RECEIPT DATE: 12/22/2021 **ONSITE SEWAGE DISPOSAL SYSTEM** P 570887
 APPROVAL DATE: 01/28/2022 **PERMIT: CONSTRUCTION** A _____
 PROPERTY ADDRESS: 18449 Hidden Creek Way
 SUBDIVISION: Windsor Forest Knolls LOT: 7 TAX ID: _____
 CONTRACTOR: FARM + HOME EXC. EMAIL: _____
 CONTRACTOR ADDRESS: _____ PHONE: _____
 PROPERTY OWNER: Keystone Custom Homes EMAIL: _____
 OWNER ADDRESS: 227 Granite Run Drive PHONE: _____
 SEPTIC TANK SIZE (GALLONS): 2000 TANK MANUFACTURER: Mayor Bros
 PUMP MODEL: _____ PUMP SIZE _____ PUMP TANK CAPACITY: _____

PROJECT:		WINDSOR FOREST KNOLLS LOT 7	
LOCATION:		TAX MAP: 6 - GRID: 16 - PARCEL: 57 18449 HIDDEN CREEK WAY - TAX ID# 04-373227 ELECTION DISTRICT NO. 4 - HOWARD COUNTY, MARYLAND	
TITLE:		ONSITE SEWAGE DISPOSAL PLAN	
HOUSE TYPE:		CUSTOM - KEYSTONE HOMES	
DATE:	MARCH, 2021	PROJECT NO.	2986
SCALE:	AS SHOWN	DRAWING	1 OF 2

PRE-CONSTRUCTION:

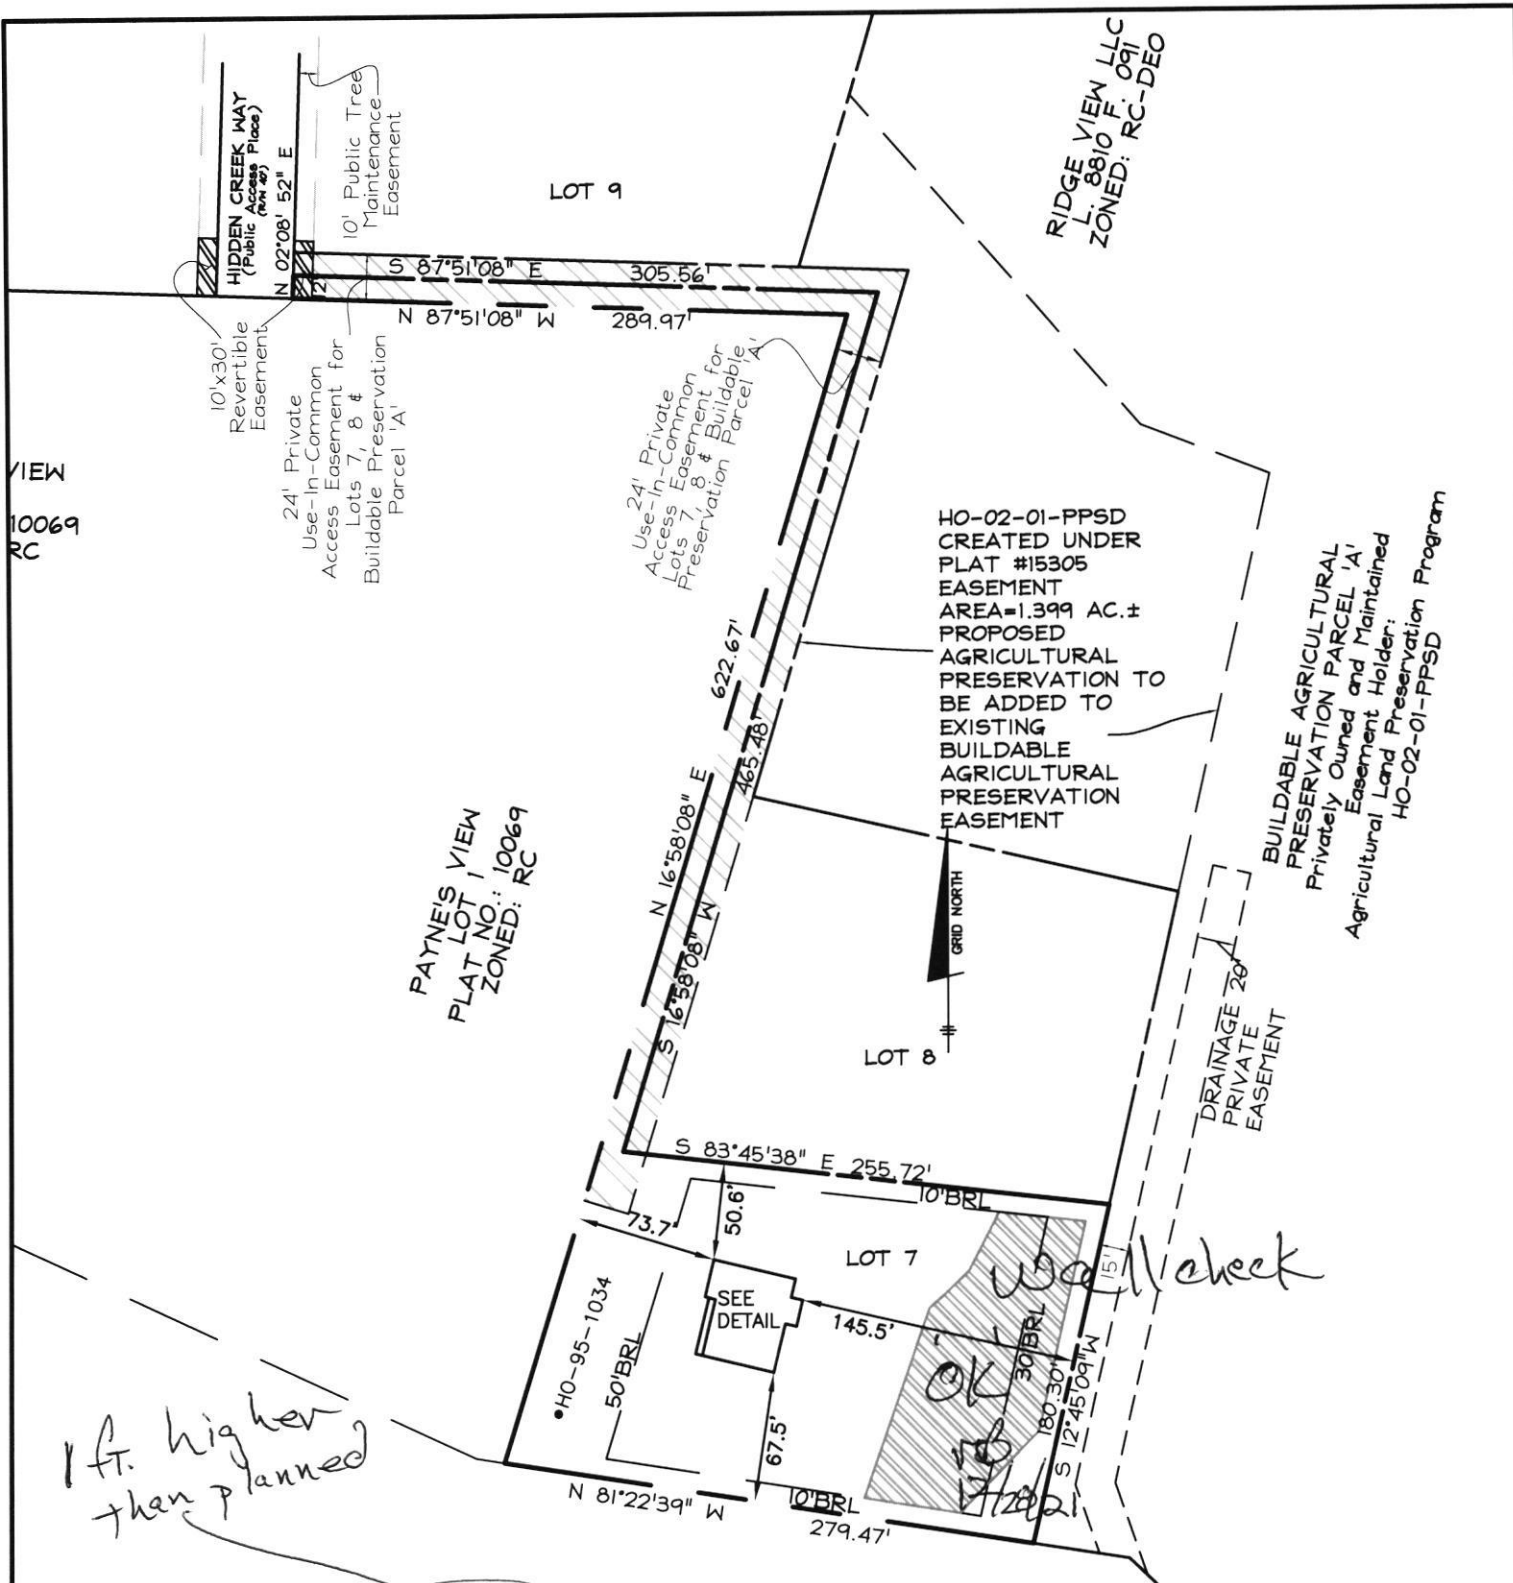
01/26/2022 LAID OUT 3x66' TRES ON CONTOUR. NOT CERTAIN 2nd REP CAN BE CONFIGURED AS SHOWN IN [ORDS 04/01/2021] CP

INSTALLATION: 01/27/2022 SHC, SL, TANK, AND D BOX SET. LOW SIDE OF TANK IS CURRENTLY ABOVE GRADE. CP 01/28/2022

FOUNDATION DETAIL
 SCALE: 1" = 30'

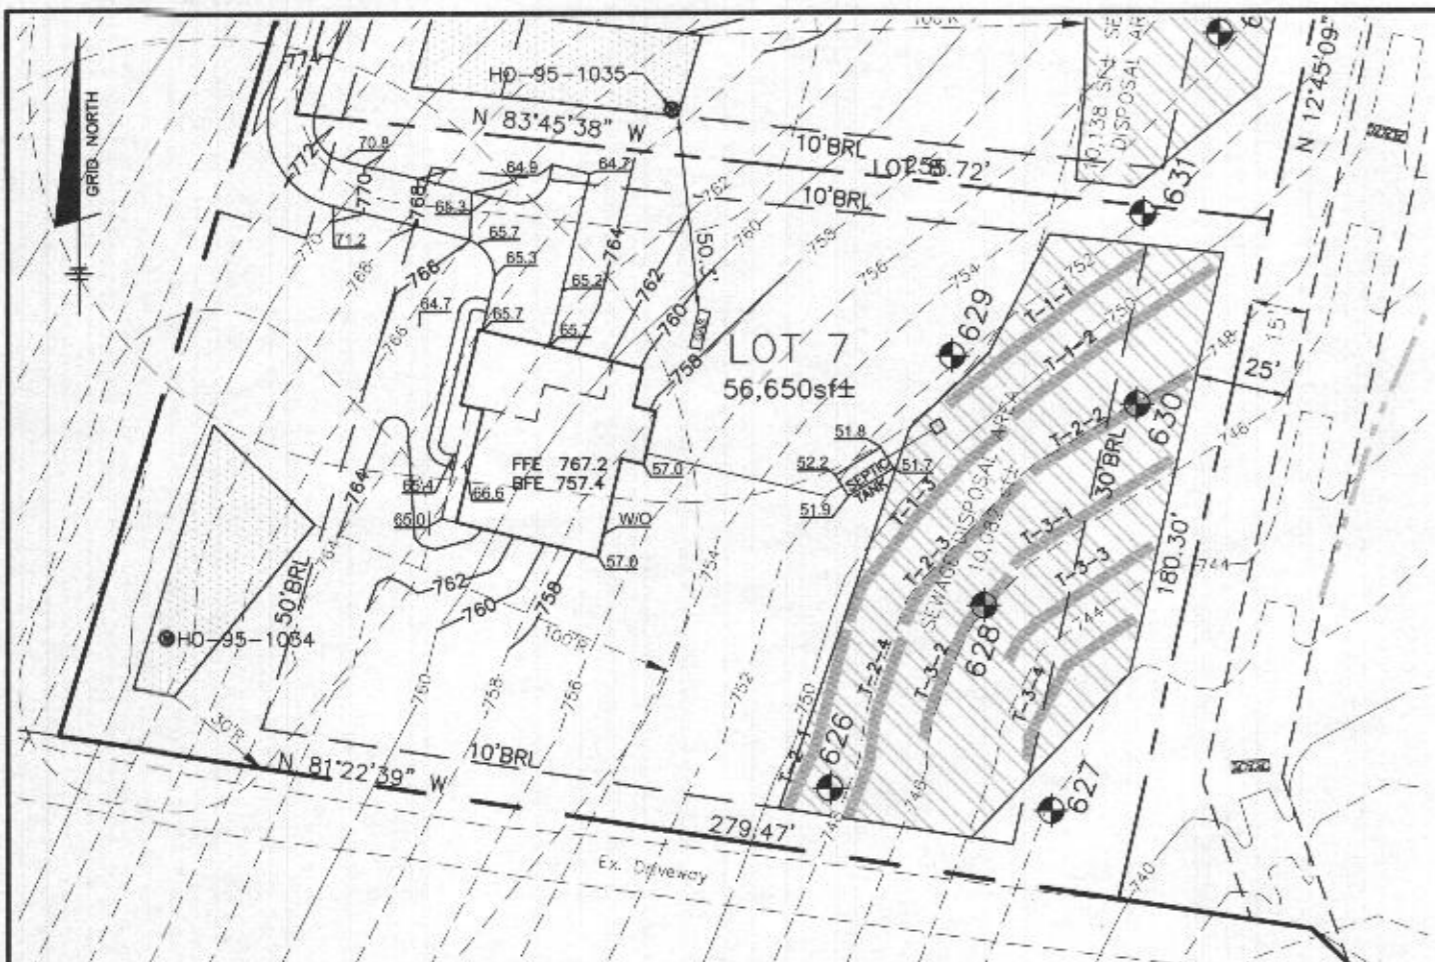
1 ft. higher
 than planned
